Department of Permitting Services
Fire Department Access and Water Supply Comments

DATE: 06-Nov-23
TO: Nancy Thompson - nthompson@vika.com
VIKA, Inc
FROM: Marie LaBaw
RE: Chevy Chase Lake Block A
120230110

RE: Preliminary Plan No. 120230110
Chevy Chase Lake Block A
Preliminary Plan Letter

Re: **COMBINED STORMWATER MANAGEMENT
CONCEPT/SITE DEVELOPMENT
STORMWATER MANAGEMENT PLAN** for
Chevy Chase Lake Block A
Preliminary Plan #: 120230110
SM File #: 289573
Tract Size/Zone: 80,404 SF/1,85 acres
Total Concept Area: 98,183 SF/2.25 acres
Lots/Block: Lots 1 – 12, Block 22
Parcel(s): N/A
Watershed: Lower Rock Creek/ Use Class 1
Redevelopment: YES

FIRE ACCESS PLAN

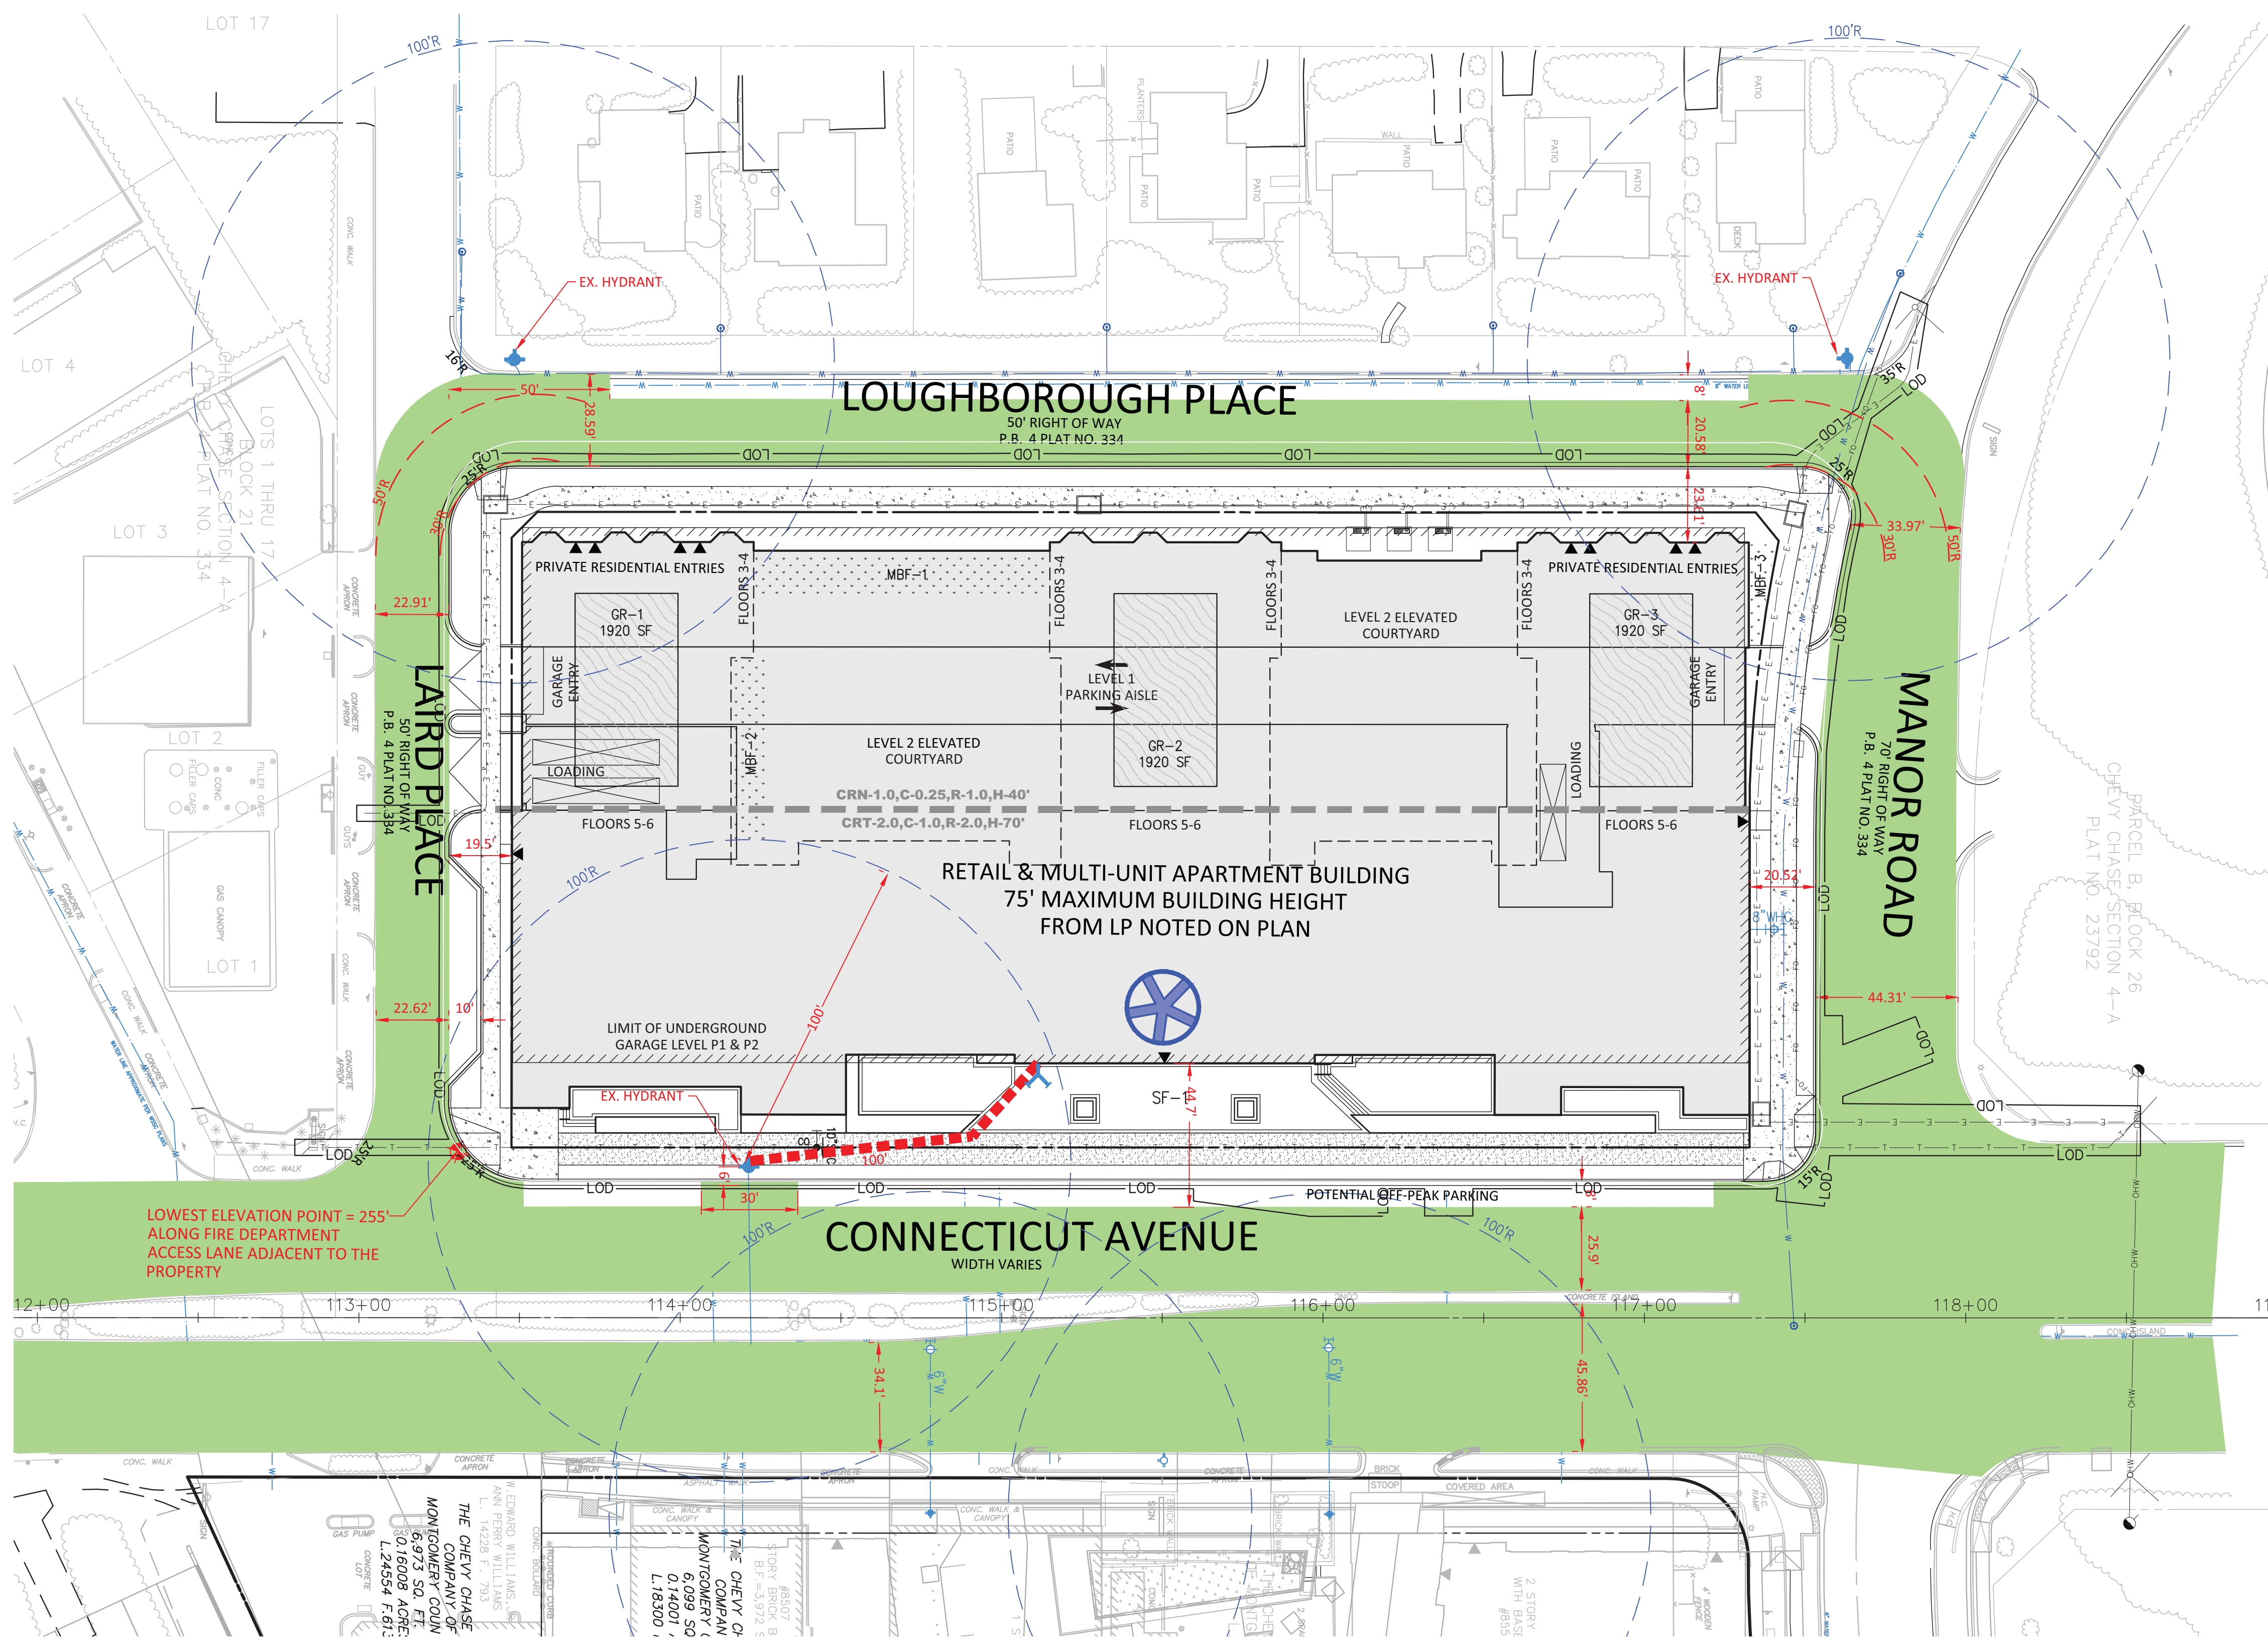
PLAN APPROVED

1. Review based only upon information contained on the plan submitted **03-Nov-23**. Review and approval does not cover unsatisfactory installation resulting from errors, omissions, or failure to clearly indicate conditions on this plan.
2. Correction of unsatisfactory installation will be required upon inspection and service of notice of violation to a party responsible for the property.

FIRE CODE ENFORCEMENT
 Fire Department Access Review
 Review based only upon information contained on this plan. Does not cover unsatisfactory layout resulting from omissions, errors or failure to clearly indicate conditions on this plan. Correction of such unsatisfactory layout to afford required access will be required if found upon inspection after installation.
 BY: *SAC* PM: 43 DATE: 11/6/2023
